## **JORDAN'S LANDING SUBDIVISION**

APPLICATION NUMBER 18 DATE August 21, 2003  
APPLICANT Jordan's Landing Subdivision  
REQUEST Subdivision

## LOCATOR MAP

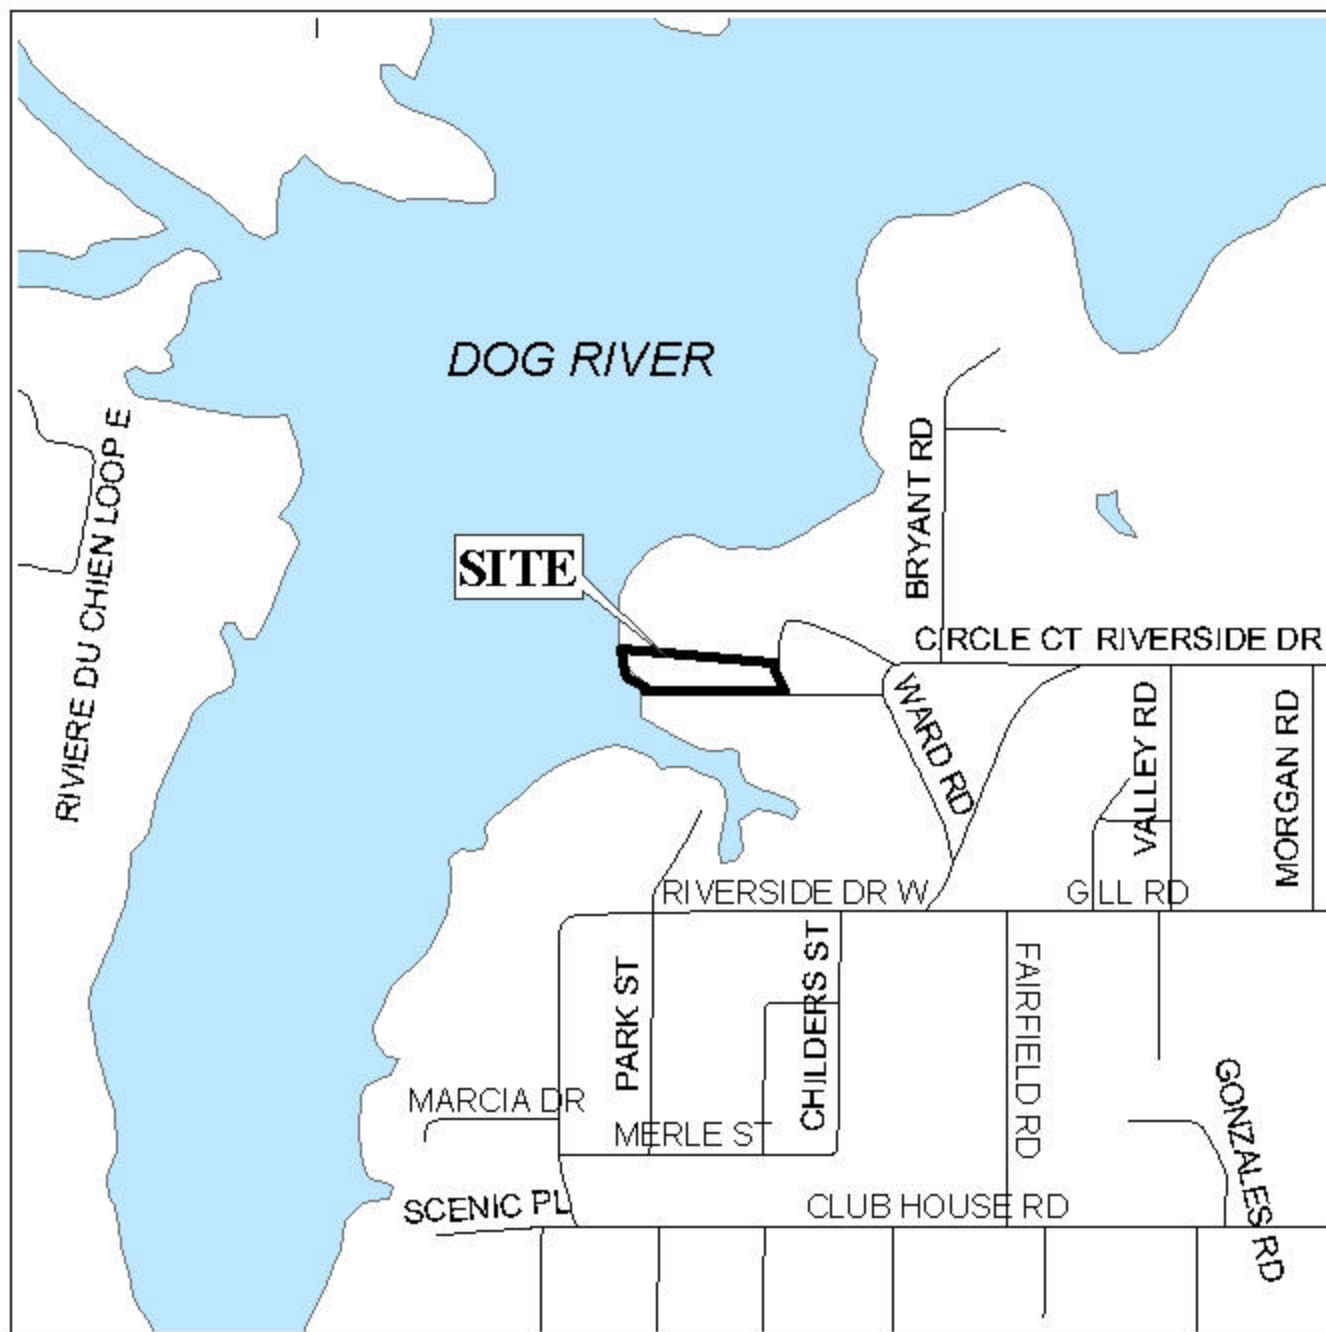
As illustrated on the Vicinity Map, the site is adjacent to Dog River, thus this area could be considered environmentally sensitive; therefore, the developer must obtain any necessary federal, state, and local environmental approvals.

## DETAIL SITE PLAN

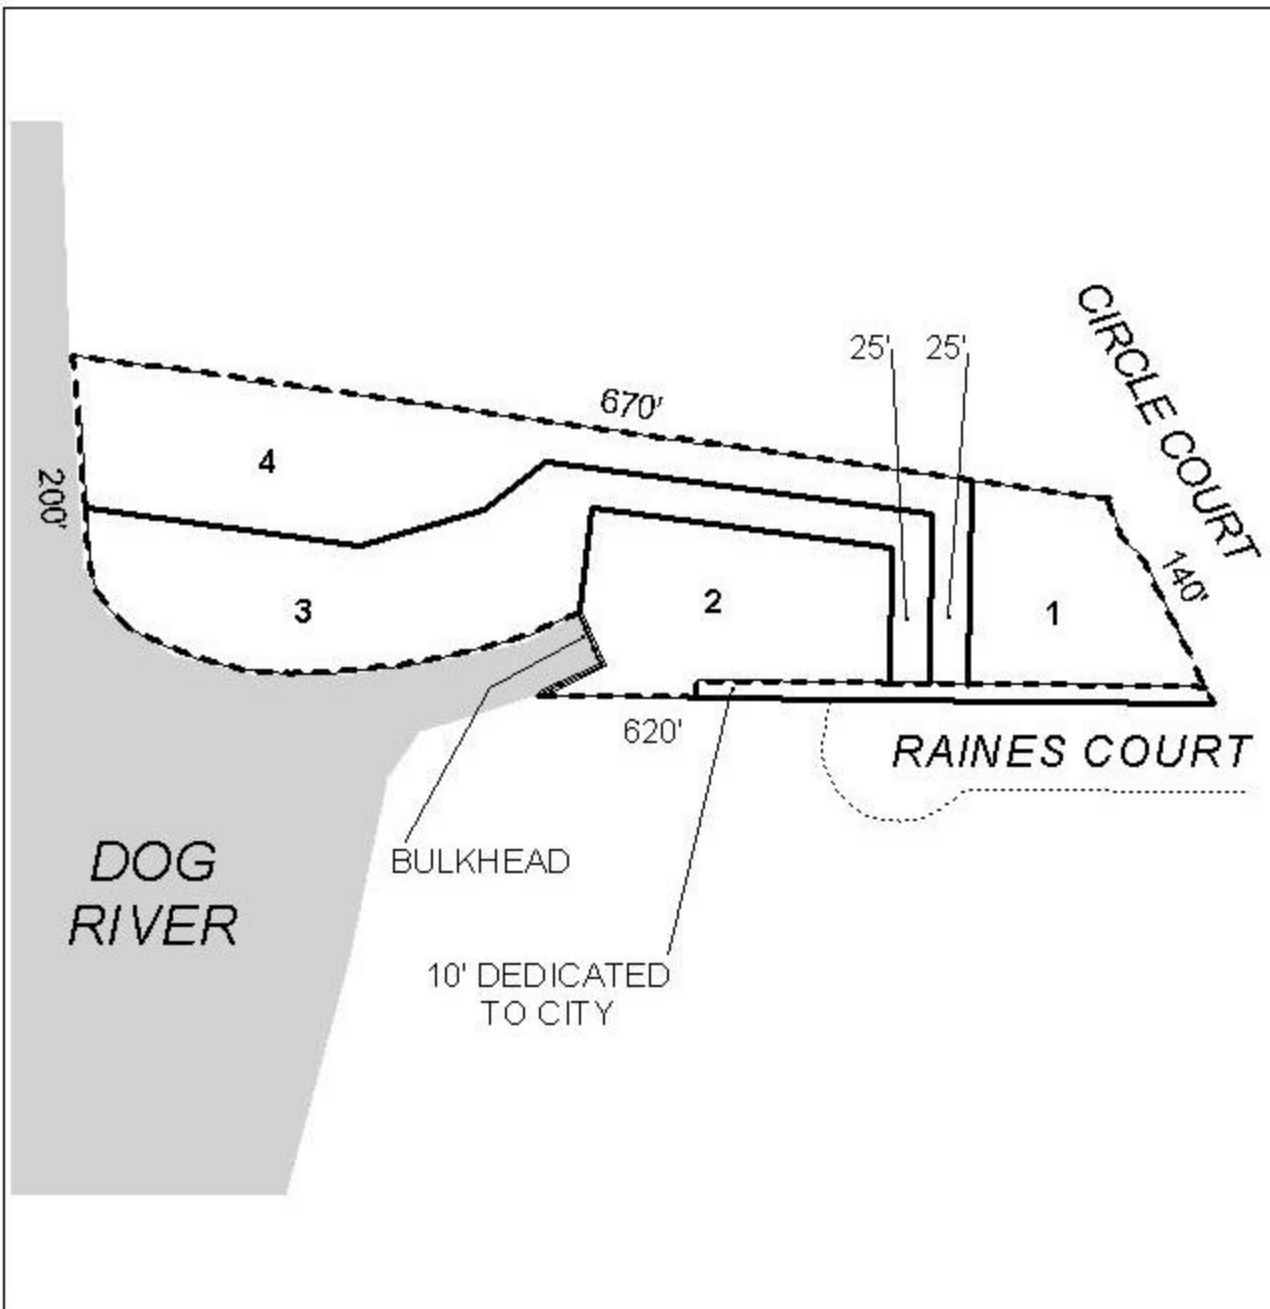
As proposed, Lots 3 and 4 would exceed the width to depth ratio, therefore a waiver of Section V.D.3 would be required.

The 25-foot minimum building setback line is not shown but would be required on the final plat.

The site also fronts Raines Court, which is currently a city maintained, substandard right-of-way. The plat illustrates that Raines Court has an existing right-of-way of 30-feet. A site visit by the Land Use Department determined the pavement width to vary from 14 feet to 19 feet. The Commission has, in isolated situations, approved subdivisions on a 30-foot right-of-way; however, determining factors are the number of lots proposed, whether or not the road is maintained by the City or County, and pavement width (a minimum of 24-feet for two-way traffic). The Commission has typically denied subdivisions where there is substandard access (less than 24-feet in width) and the number of lots is increasing.

The site has frontage on Circle Court Drive and the right-of-way of Circle Court Drive is not indicated. The pavement has no curb, wing gutters, and the width is narrower than Raines Court.

Based upon the preceding, this application is recommended for denial for the following reason:  
1) the only access to the site is via a substandard street, both in terms of right-of-way width and improvements.
